Accessibility Survey

Adoree Street & Columbia Way

Date of Inspection
4/10/2017

Disability Access Consultants

Sidewalks , Change in Level : Change in Level Non Beveled

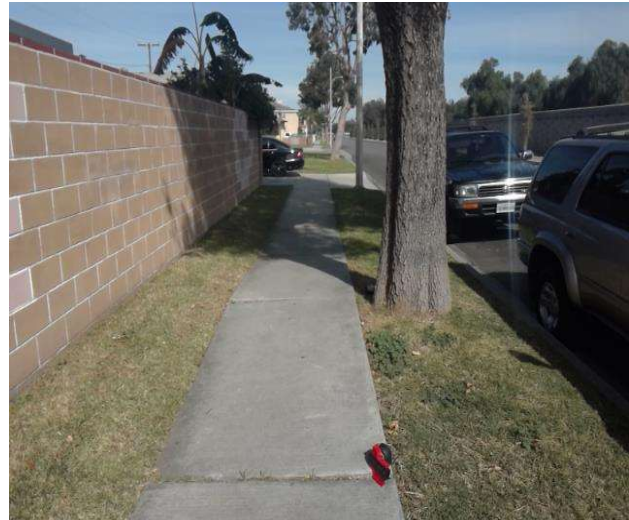
There is a change in elevation greater than recommended value.

On-Site Finding 1.25 inches

Ensure that the change in elevation is within the recommended value.

Sidewalks , Change in Level : Change in Level Non Beveled

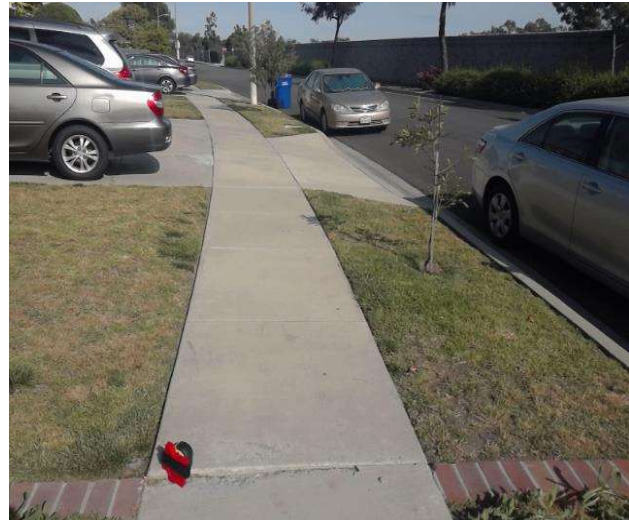
There is a change in elevation greater than recommended value.

On-Site Finding 1.00 inches

Ensure that the change in elevation is within the recommended value.

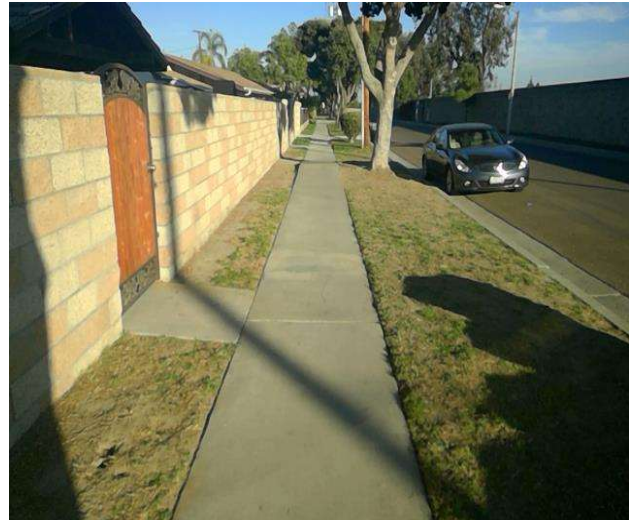
Sidewalk cross slope is not compliant.

On-Site Finding 3.00 percent for 42.00 feet

Repave the sidewalk surface with the recommended cross slope.

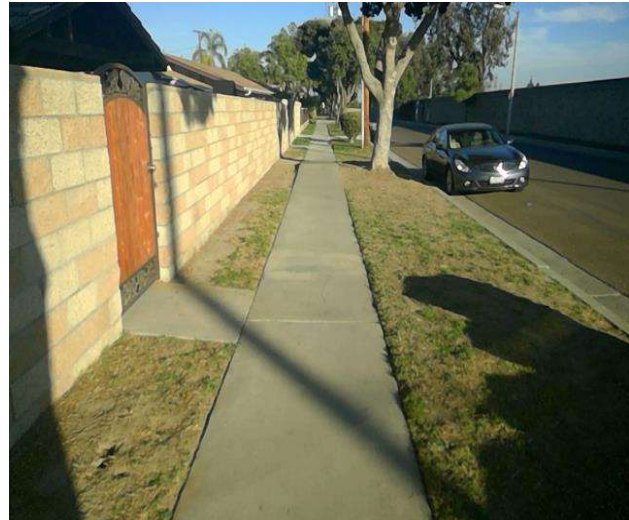
Sidewalk running slope is not compliant.

On-Site Finding 6.80 percent for 42.00 feet

Repave the sidewalk surface with the recommended running slope.

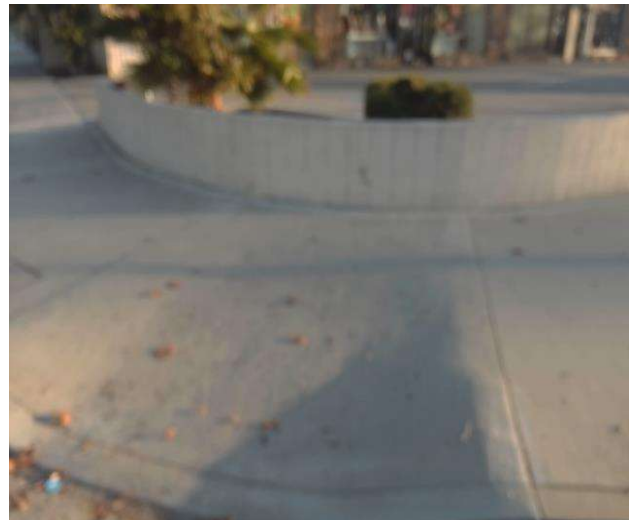
The bottom landing of the curb ramp is on the street, and the slope of the bottom landing is not compliant.

On-Site Finding 8.70 percent

Ensure the bottom landing slope is compliant and provides a smooth transition.

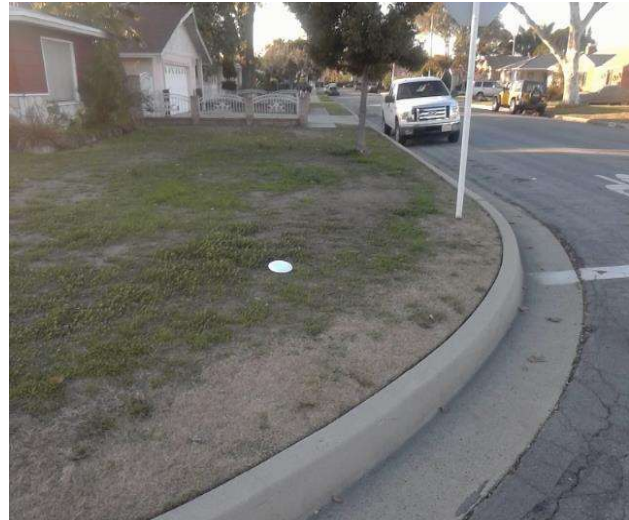
There is a curb on the designated path of travel.

On-Site Finding Not Compliant

Provide a compliant curb ramp.
